NFPA STANDARDS DEVELOPMENT SITE SECOND DRAFT REPORT

Released Version Closing Date: March 03, 2026

NFPA 101®, *Life Safety Code*®, 2024 Edition

Figure 7.3.1.2(a) Mall Structure Occupant Load Factors (US Customary Units).

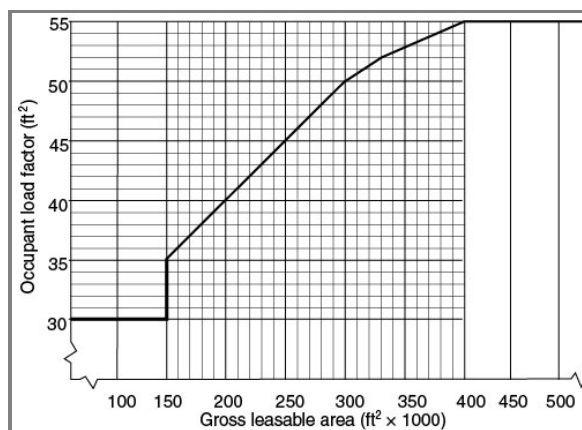
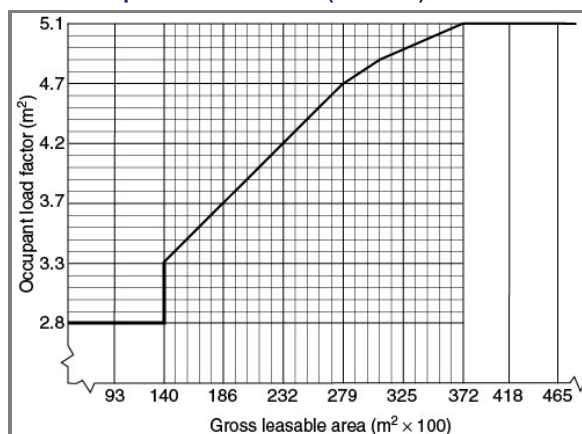
Statement of Problem and Substantiation for Public Comment

Committee Statement

Committee Action: Rejected

Figure A.7.2.1.2.2(a) Door Width — Egress Capacity.**Figure A.7.2.1.2.2(b) Door Width — Egress Capacity with Permitted Obstructions. Width Measurement with Boundary/Edge Effect Clearances. <<Replace Figure A.7.2.1.2.2(b) with one of the attached figures.**

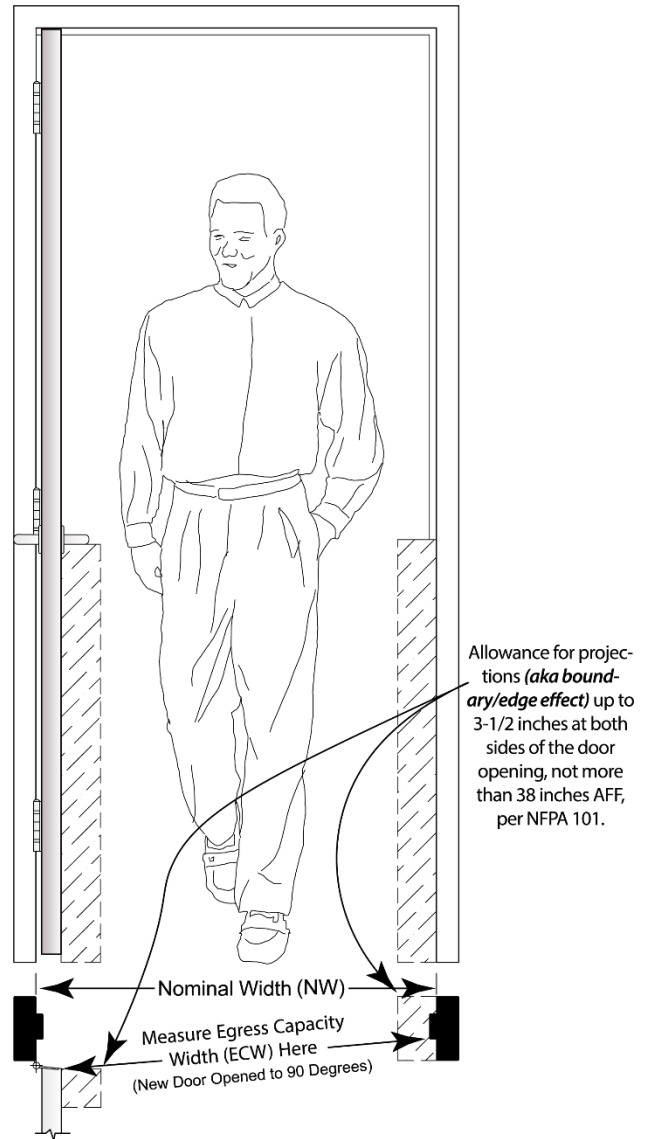
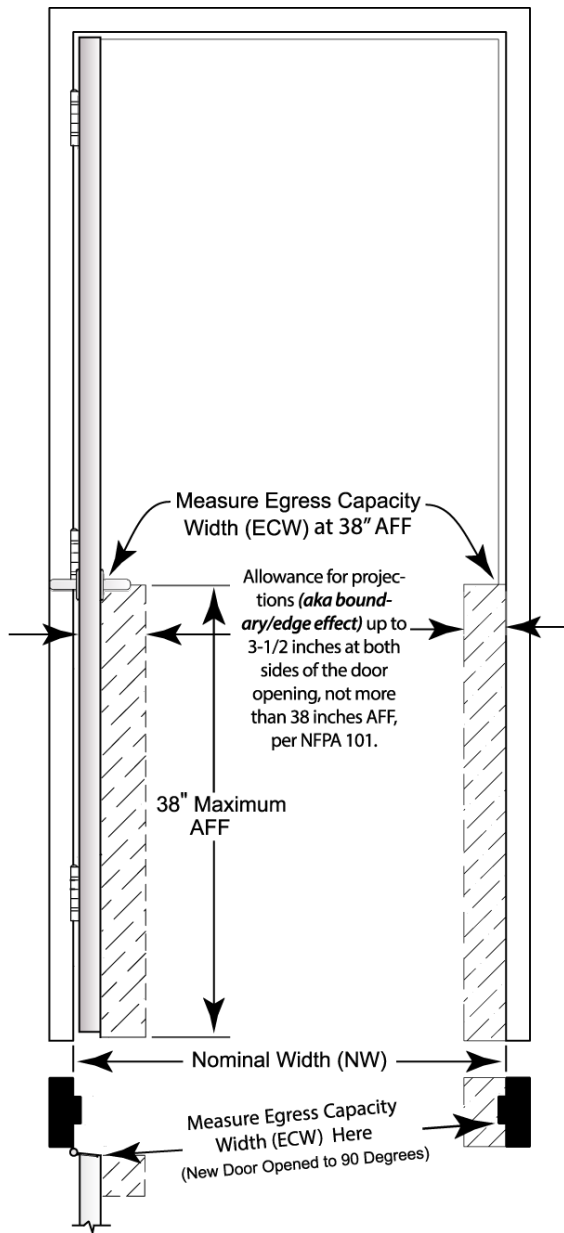
means of egress (other than door openings) for purposes of calculating egress capacity. The egress capacity of door openings is regulated by 7.2.1.2.2.1, which substitutes a maximum 3½ in. (90 mm) projection at each side of the door opening in place of the 4½ in. (114 mm) projections permitted by 7.3.2.2. Figure A.7.2.1.2.2(b) depicts the allowable encroachment at each side of a door opening.

"The egress capacity of door openings is regulated by 7.2.1.2.2.1, which substitutes a maximum 3½ in. (90 mm) projection at each side of the door opening in place of the 4½ in. (114 mm) projections permitted by 7.3.2.2. Figure A.7.2.1.2.2(b) depicts the allowable encroachment at each side of a door opening."
